# SERVICE LETTER

HL-120  
DL-96  
EL-47  
FL-41

TO: ALL OWNERS AND OPERATORS OF MCDONNELL DOUGLAS HELICOPTER COMPANY (MDHC) 369 SERIES HELICOPTERS EQUIPPED WITH SHOCK-MOUNTED SKID TUBE POSITION LIGHT ASSEMBLIES (P/N 369H92041-35/-36).

## AVAILABILITY OF IMPROVED SPACERS TO BE USED ON THE SHOCK-MOUNTED SKID TUBE POSITION LIGHT ASSEMBLIES

**Figure 1. Skid Tube Position Light Assembly**

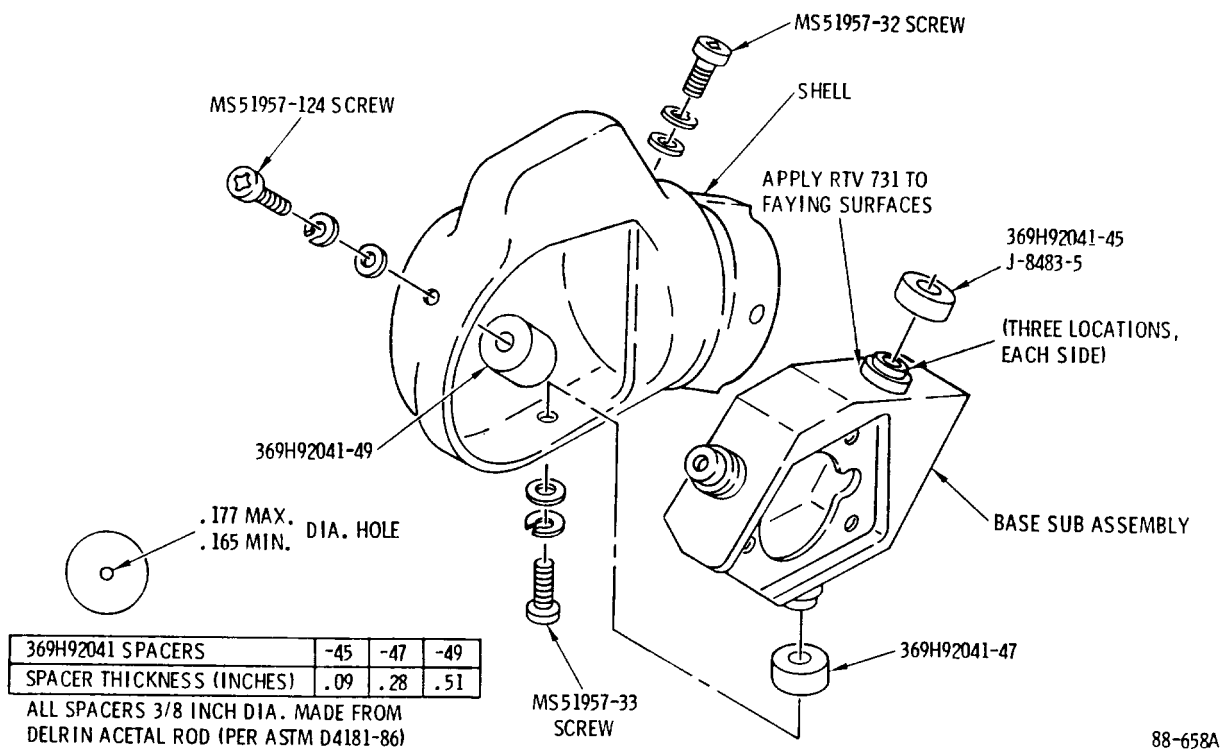
MDHC has received reports that some Lord shock mounts on the skid-mounted position light assemblies have been tearing in service. MDHC has improved the design with a change in mounting hardware and mounting procedures. The following parts list and procedure provides operators with instructions to modify their light assemblies to the improved configuration.

- a. Remove the left and right hand base sub-assemblies by removing (3) screws and associated hardware (each side). Discard existing spacers and mounting screws.
- b. Bond the three J-8483-5 isolator mounts to their respective base sub-assemblies using RTV 731
- c. Reinstall base sub-assemblies using the spacers and screws called Out in Figure I and the above parts list. Offer associated hardware is shown in Figure 1 and called out in the applicable illustrated parts catalogs.
